**MEMORANDUM**

**To:** Mayor and City Council  
**From:** Michael Smith, Public Works Director  
**Date:** September 8, 2014  
**Subject** **4400 Ashford Dunwoody Road:** Request to waive right of way dedication and street improvement requirements of Sec. 16-222

**ITEM DESCRIPTION**

SHEET TITLE  
**SITE PLAN**

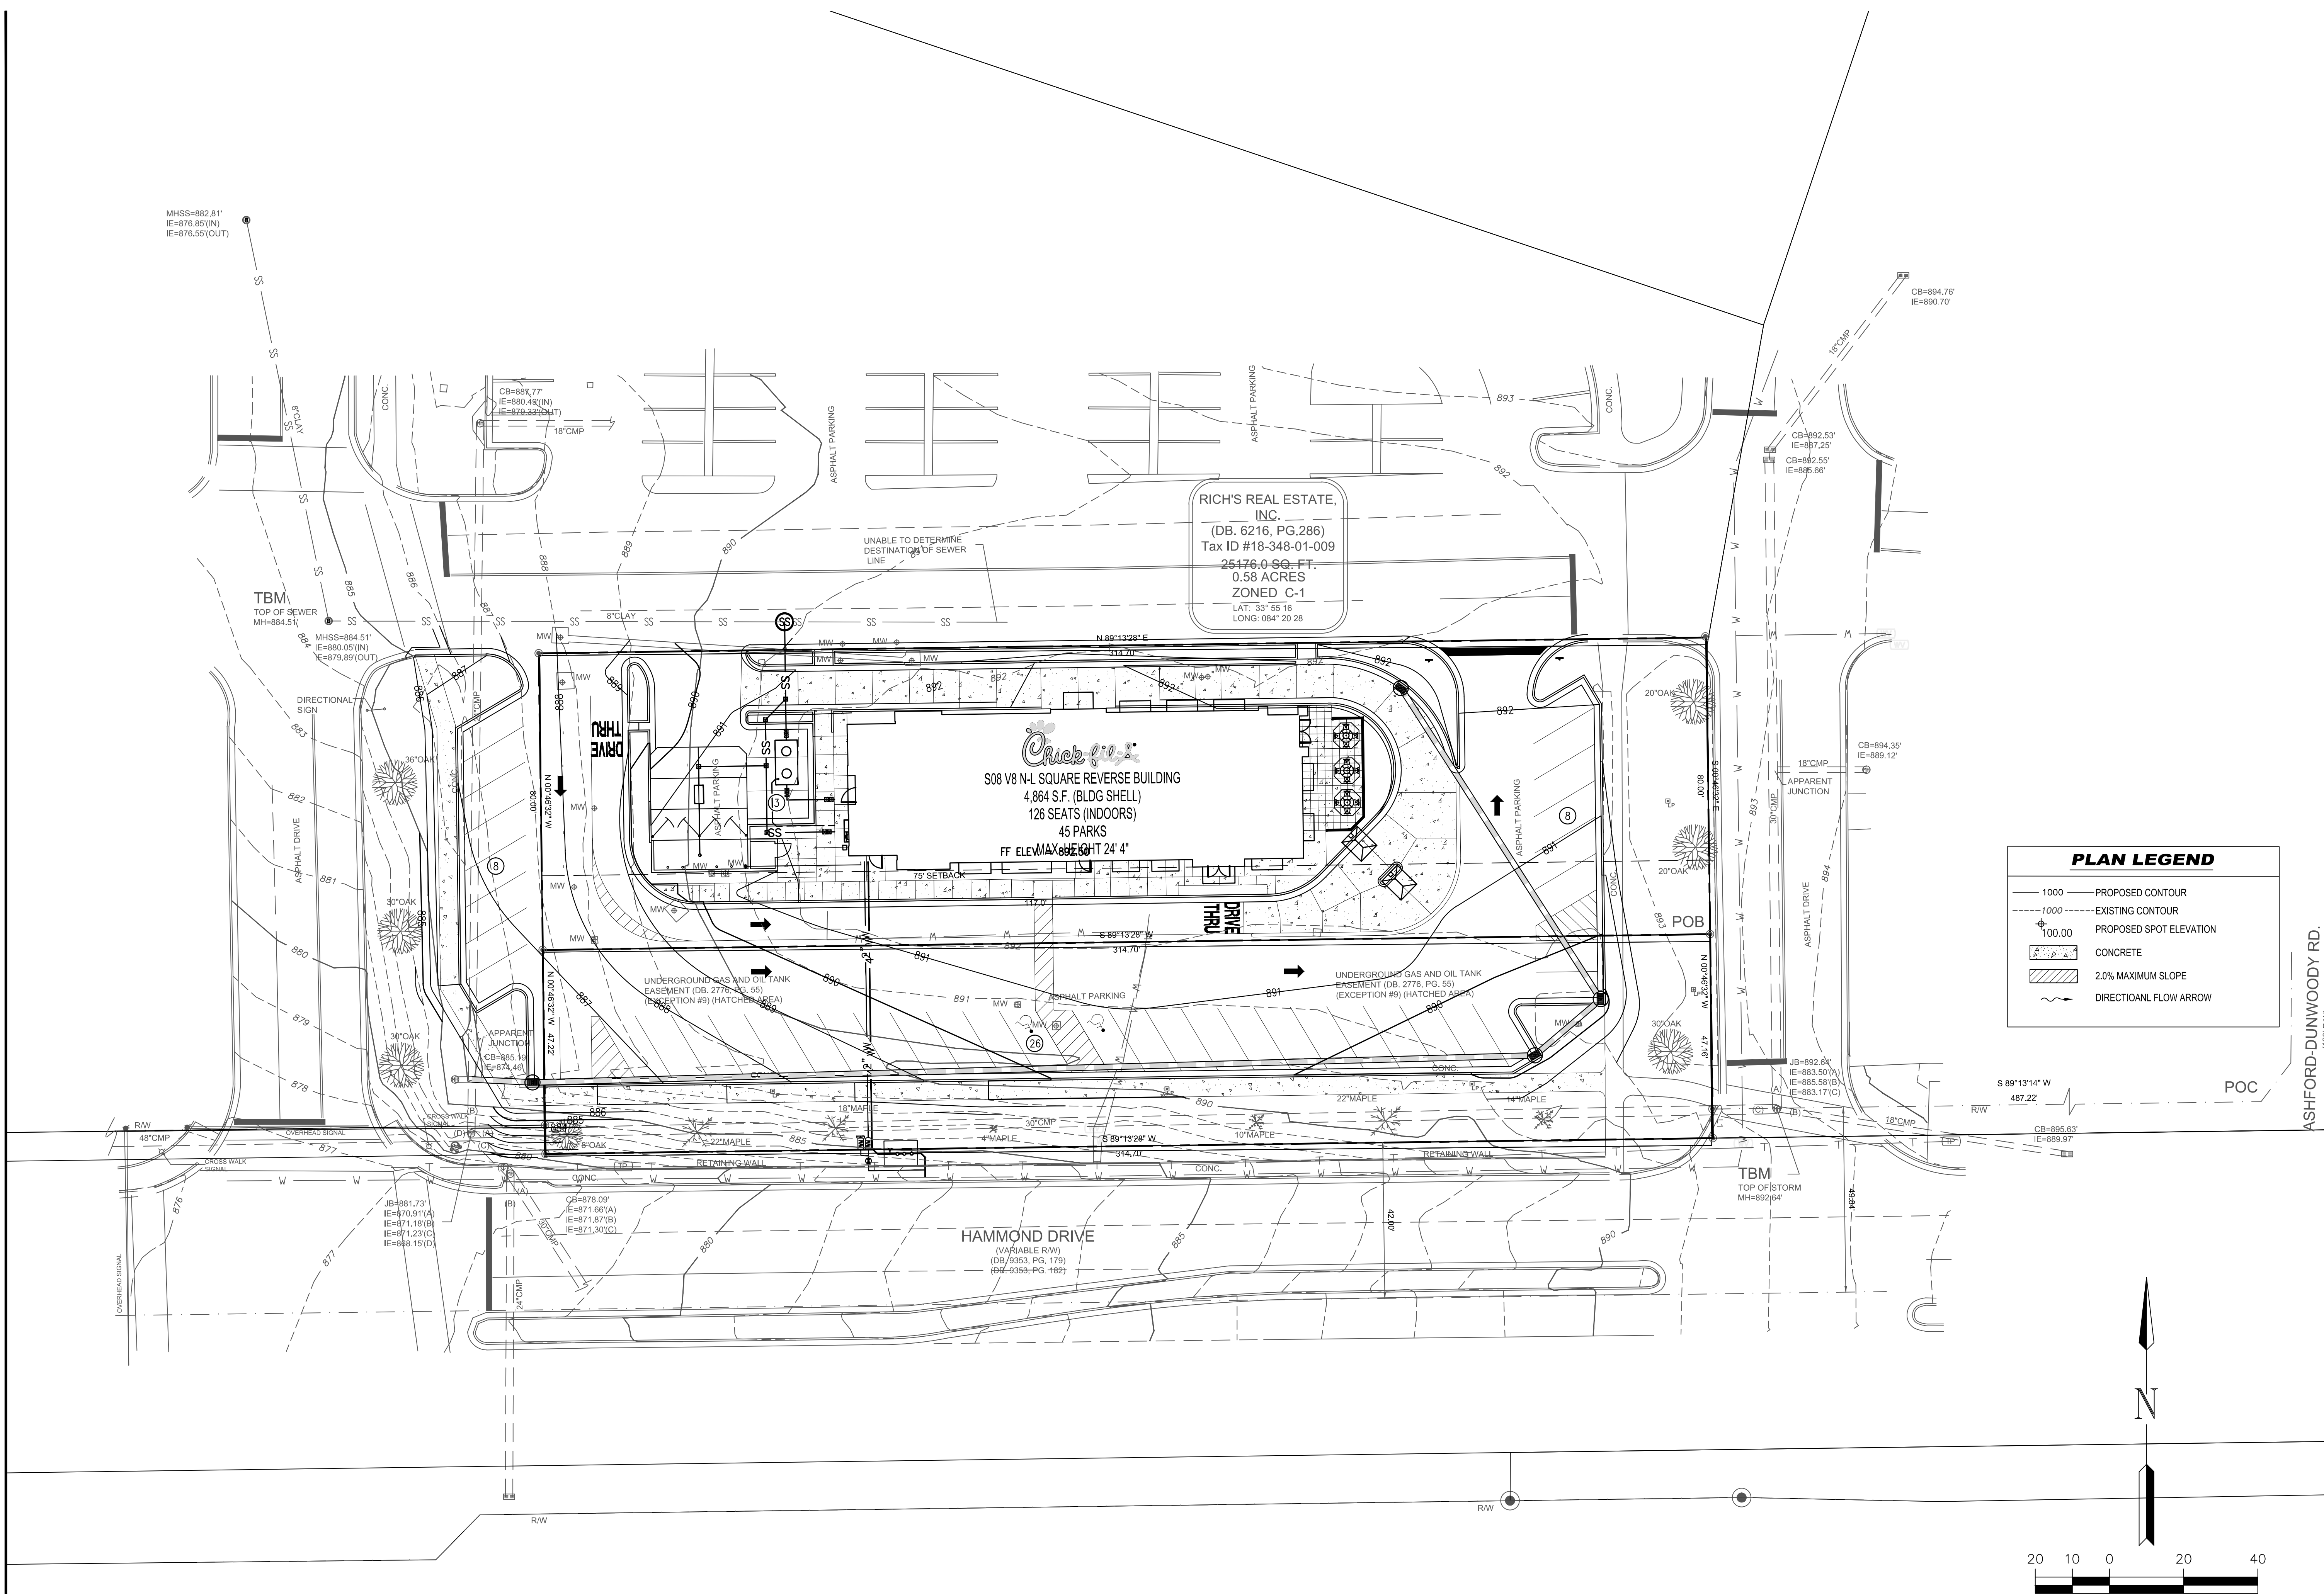
The applicant has submitted for a conceptual review to demolish the existing auto service center at Perimeter Mall and build a new Chick-Fil-A restaurant (application attached). The site is located between two entrances to the mall property on Hammond Drive. The applicant has requested a waiver of the right of way dedication and street improvements required by Section 16-222 of the city’s code of ordinances. The required street improvements include a bike lane, landscape buffer and sidewalk.

- The Chick-fil-A has entered a sub-lease with Macy’s. It is a small area surrounding the current building location and has a construction easement to upgrade the parking lot to accommodate the new building being erected in place of the auto center. The property between the sub-lease and easement area and the city right of way is owned by the Mall. Chick-fil-A does not currently have the legal rights to encroach into this area.
- There is a fire hydrant, sewer manhole and pedestrian signal pole that will need to be adjusted to accommodate the new sidewalk.
- A three to four foot high retaining wall will be required at the back of the sidewalk.
- An additional six trees would have to be removed.

The site is located less 900 feet from the Dunwoody MARTA station which is well within the distance that a typical person would walk or bike to access transit. There are currently no bicycle facilities on Hammond Drive. Along the site frontage, there is an existing sidewalk approximately four feet wide with no landscape buffer and a short wall at the back of the sidewalk (picture attached). The relatively narrow sidewalk placed between a wall and the edge of the vehicle travel lanes is less than ideal for pedestrians and is not consistent with city or PCIDs goals of creating a pedestrian friendly street environment. Due to the slope between the roadway and the site parking lot, any widening of the roadway to better accommodate bicycles or pedestrians will necessitate construction of a new retaining wall and removal of six trees, only two of which appear mature and healthy.

Staff recommends **denial** of the applicant's request to waive the requirements for right of way dedication and the street improvements, as the request does not meet any of the criteria set forth in Section 16-222.k.5. Additionally, a waiver of the improvements would be inconsistent with the adopted plans for the area. Finally, a waiver of the right of way dedication would make it more difficult for the city to construct the recommended road improvements in the future. Recognizing the challenges with topography and utilities at the site, staff requests the ability to make minor adjustments to the required street cross section as necessary to minimize impacts while still meeting the intent of the code.
